Office Action Summary	Application No. 10/582,339	Applicant(s) OMORI ET AL.	
	Examiner DIRK BASS	Art Unit 1777

DETAILED ACTION

1. The text of those sections of Title 35, U.S. Code not included in this action can be found in a prior Office action.
2. **Claims 1-3, 5-6, 8-14, 20 and 53** are rejected under 35 U.S.C. 103(a) as being unpatentable over Motoya et al., JP 09-187646 (Motoya) in view of Omori et al., US 6689465 (Omori).

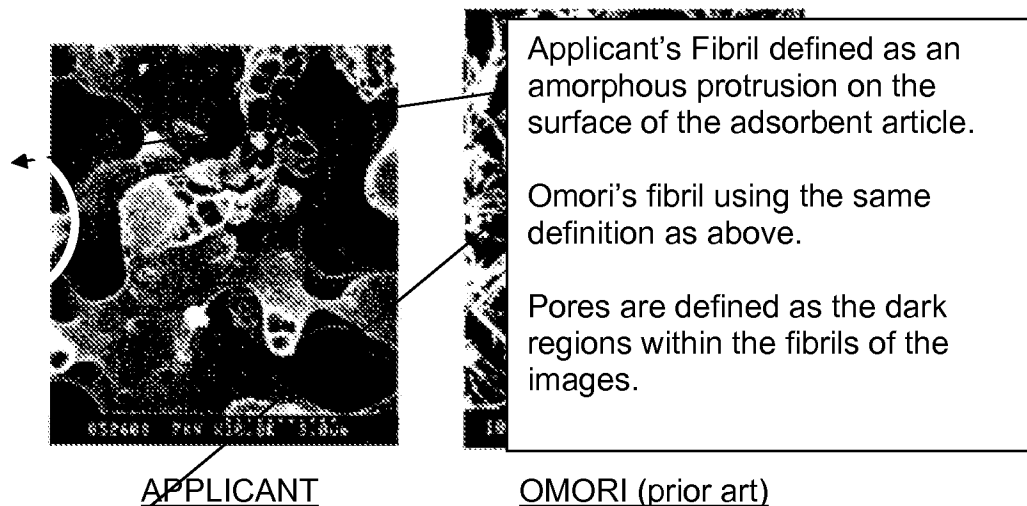
28. Applicant's declaration filed September 21, 2010 is not persuasive. The examiner directs applicant's attention to the images provided on page 4 of the declaration, said images provided below.

When comparing the scale of the images above, the examiner notes that the scale of the image on the left is 3 microns (denoted by 11 dots) whereas the scale of the prior art image is 2 microns (denoted by 11 dots). The amorphous protrusion shown in the middle of applicant's image is about 3 microns across, and has what appear to be windows formed and framed by white lines. If the examiner is to interpret the windows of the image to be pores, then the examiner considers the white lines to be fibrils. In Omori, the fibrils appear to be about 0.2 microns thick and form similar pores as shown in applicant's image. Thus the examiner considers the structures provided in applicant's image and that of Omori to be the same or similar.

Furthermore, since applicant has not provided a clear definition of a fibril, the examiner is taking the broadest reasonable interpretation of what a fibril is, namely a small fine fiber or filament.

According to the images above, the examiner interprets a fibril to be a protrusion on the surface of the adsorbent article. As seen above, Omori clearly discloses fibrils having a porous structure (see dark spaces within the fibril). Therefore, the examiner maintains that the claims as recited are obviated by the combination of Motoya and Omori. Furthermore, since applicant has not recited the specific material of the porous formed article in claim 1, the examiner is using the broadest reasonable interpretation of Omori in obviating the porous fibril structure.
